## RTB Reissue

Subject: Service remarks at installation		Prepared by: T. Itoh	
From: Technical Service Sec. Service Planning Dept.			
Classification:	<input type="checkbox"/> Troubleshooting	<input type="checkbox"/> Part information	<input type="checkbox"/> Action required
	<input type="checkbox"/> Mechanical	<input type="checkbox"/> Electrical	<input type="checkbox"/> Service manual revision
	<input type="checkbox"/> Paper path	<input type="checkbox"/> Transmit/receive	<input type="checkbox"/> Retrofit information
	<input checked="" type="checkbox"/> Other (Specification change)

Model: Model J-P2		Date: 2-Apr-03	No.: RG080001
Subject: Service Manual Revision		Prepared by: H.Taguchi	
From: 1st Tech. Support Sec. Service Support Dept.			
Classification:	<input type="checkbox"/> Troubleshooting <input type="checkbox"/> Mechanical <input type="checkbox"/> Paper path <input type="checkbox"/> Other (      )	<input type="checkbox"/> Part information <input type="checkbox"/> Electrical <input type="checkbox"/> Transmit/receive	<input type="checkbox"/> Action required <input checked="" type="checkbox"/> Service manual revision <input type="checkbox"/> Retrofit information

Please apply t

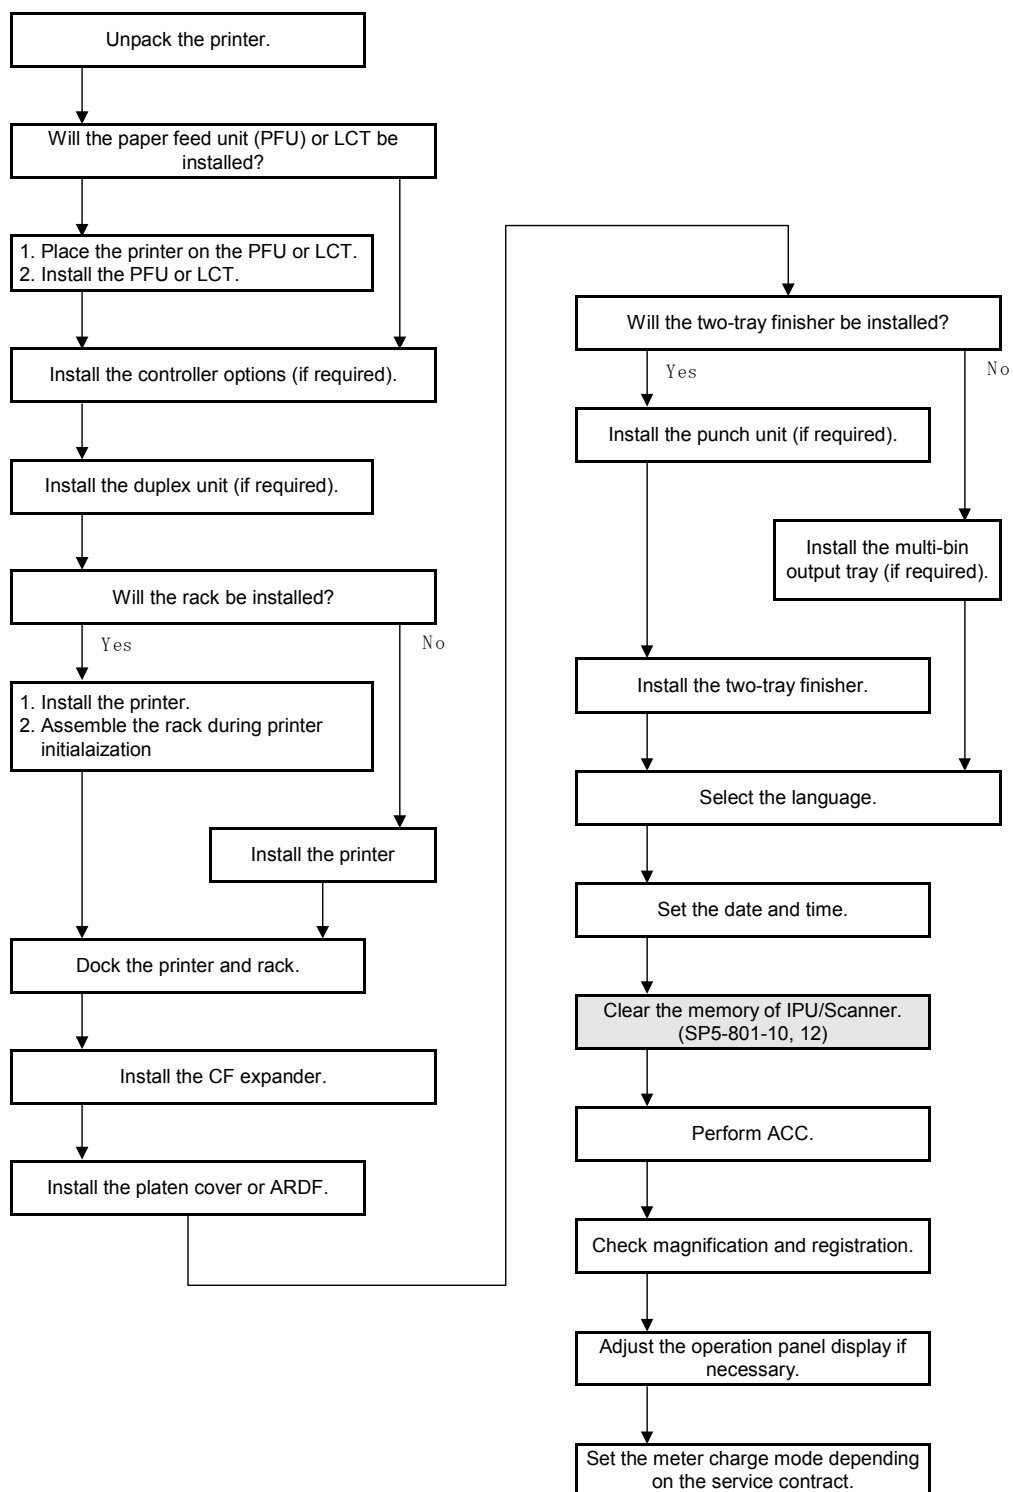
Contents revised: The following bold word was deleted from the flowchart illustration.

Clear the memory of IPU/**Netfile**/Scanner (SP-5-801-10,12) ].

## Page 3-10

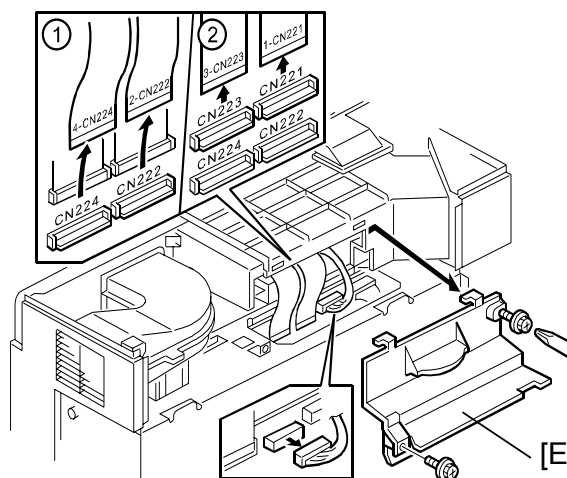
- A screw has been added and the shape of the connector cover has been changed as follows.

- Step 12 revised as follows:

12. Connector cover [E] (Screw x **2**)

## Page 3-23

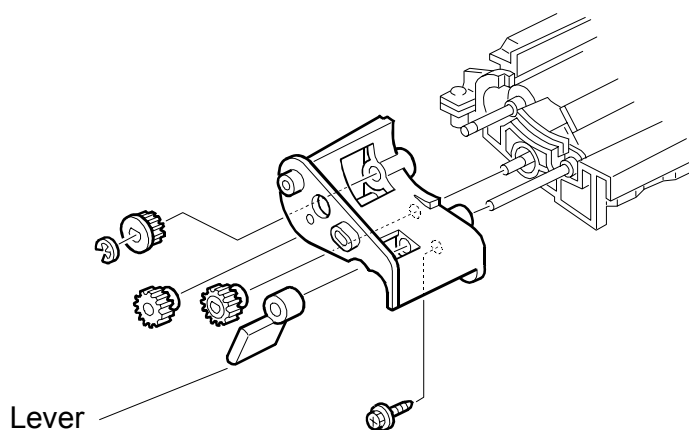
- The screw which stops the lever has been deleted, and the shape of the lever has been changed as follows.

- Step 4 deleted.

4. Lever [C] (Screw x 1)

## Page 3-25

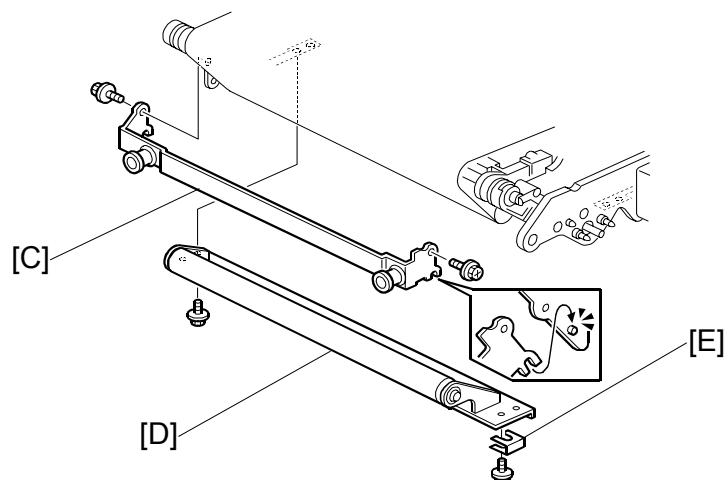
- A spacer [E] has been added.

- Step 6 revised as follows.

6. Tension roller [D] (**Spacer [E] x 1**, Screw x 2)

Page 3-42

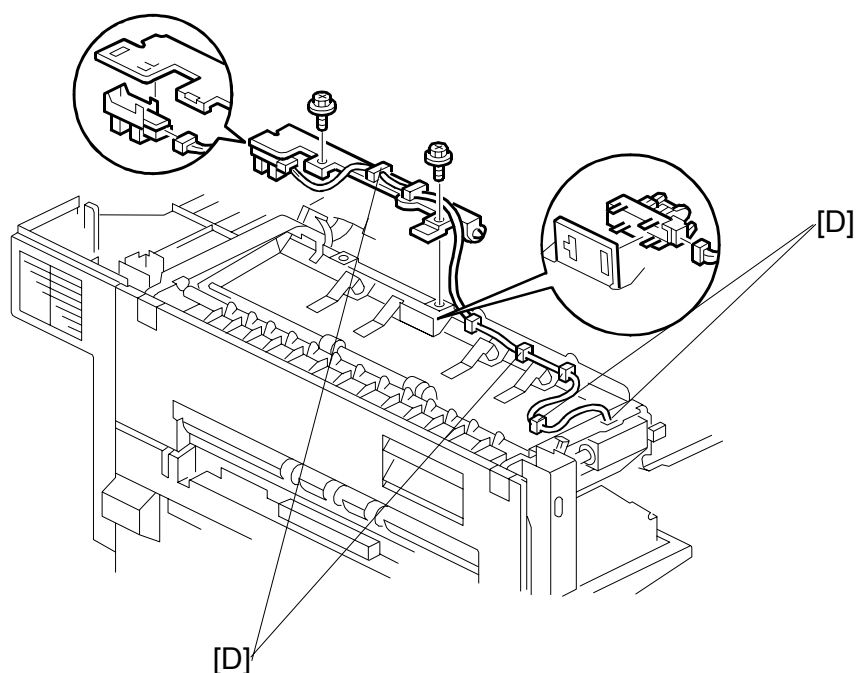
- Four clamps [D] have been added, and the attachment of the harness has been changed as follows. The clamp at the right-hand end is not visible in the drawing.

## Page 3-43

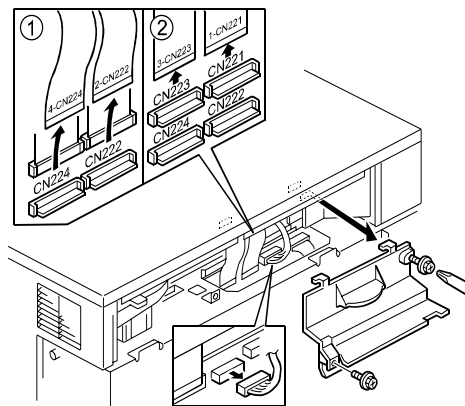
- A screw has been added, and the shape of the connector cover has been changed as follows.

- Step 4 revised.

4. Connector cover [E] (Screw x 2)

Page 3-45

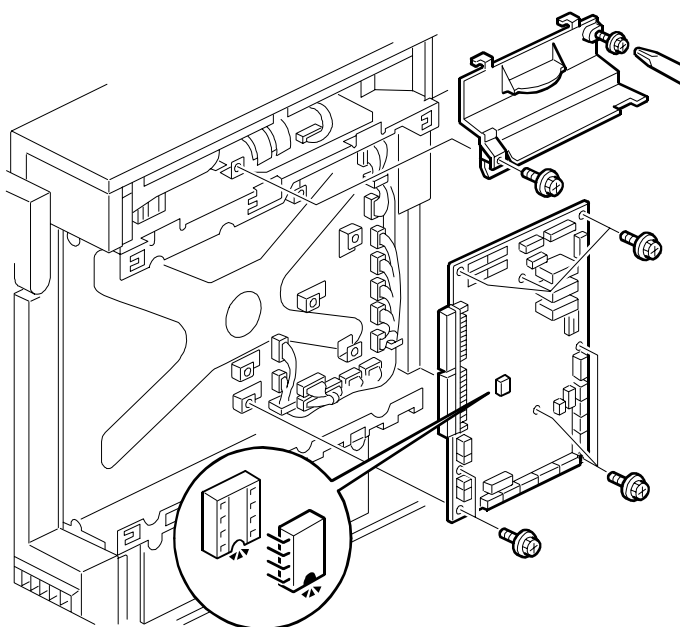
- A screw has been added and the shape of the connector cover has been changed as follows.

- Step 6 revised.

6. Connector cover [E] (Screw x 2)

**Page 3-50**

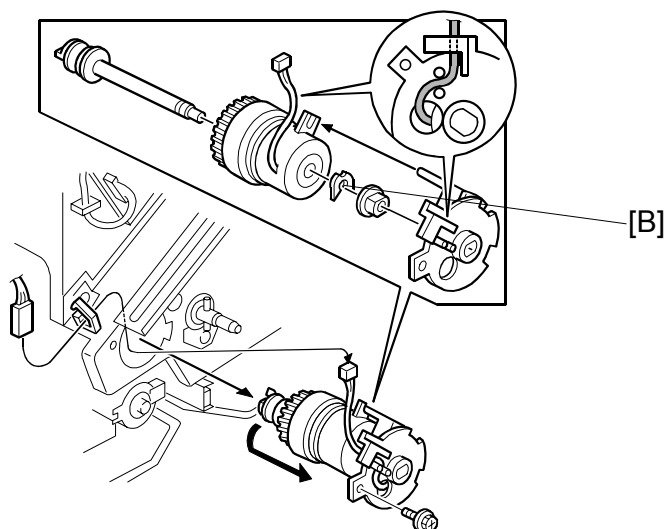
- A retaining ring [B] has been inserted between the magnetic clutch and the bushing, as follows.

- Step 3 revised.

3. Development clutch [A] (Connector x 1, Screw x 1, **Retaining ring [B] x 1**)

Page 6-42

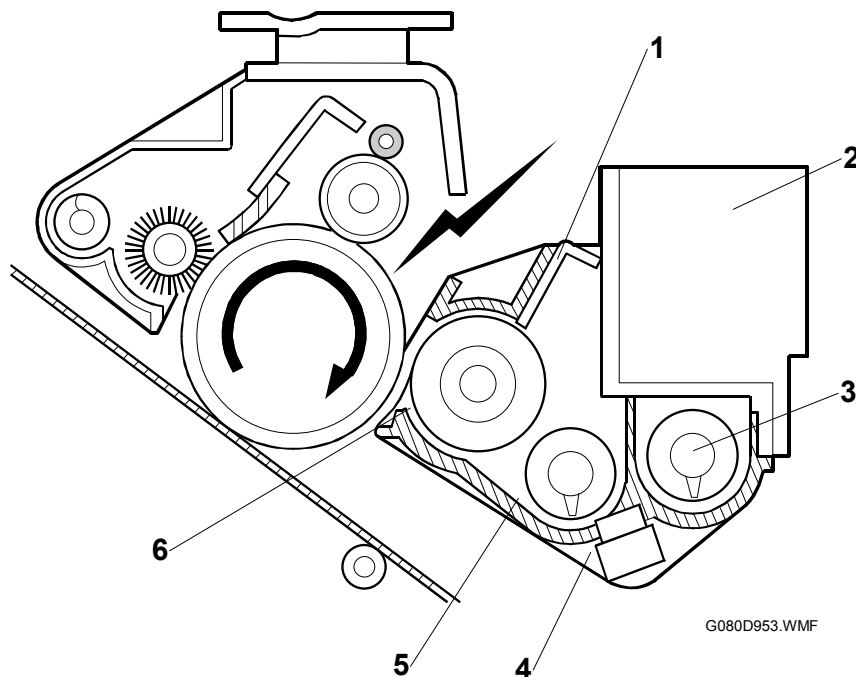
- Illustration revised to show correct parts:

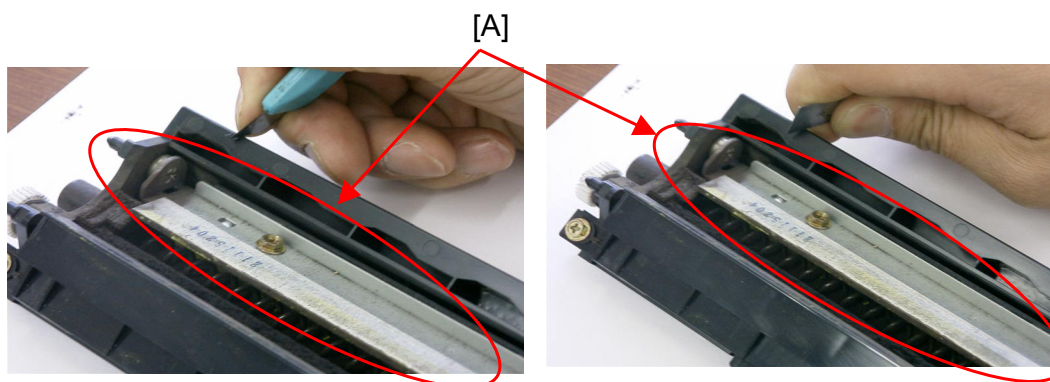
1. Turn off the main switch.
2. Open the front cover and pull out the paper transfer unit (1 screw).
3. Remove the cleaning unit, holding the cleaning blade release lever (1 screw).
4. Place the cleaning unit onto a sheet of paper, as shown below.
5. Using the blunt side of a box cutter or metal ruler, file down the edge [A] of the cleaning unit case, from front to rear, by approximately 1.5 mm (0.06 in.).

**NOTE:** Make sure to prevent any plastic particles from getting inside the cleaning unit, e.g. by covering the open space [A] with a sheet of paper. If any particles get into the unit, it can cause damage to the cleaning blade, resulting in dirty lines on the rear side of outputs.

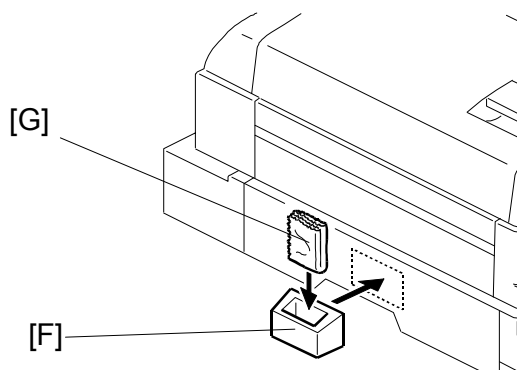
- **Attach the cloth holder [F] to the left face of the scanner unit.**
- **Place the contact glass cleaning cloth [G] in the cloth holder [F].**

Illustration added:

**Page 3-32**

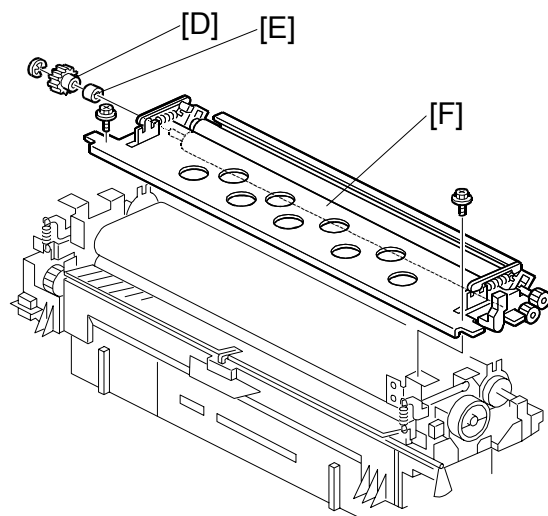
Illustration revised to show the gear and collar:

- Steps 4, 5 revised as follows:
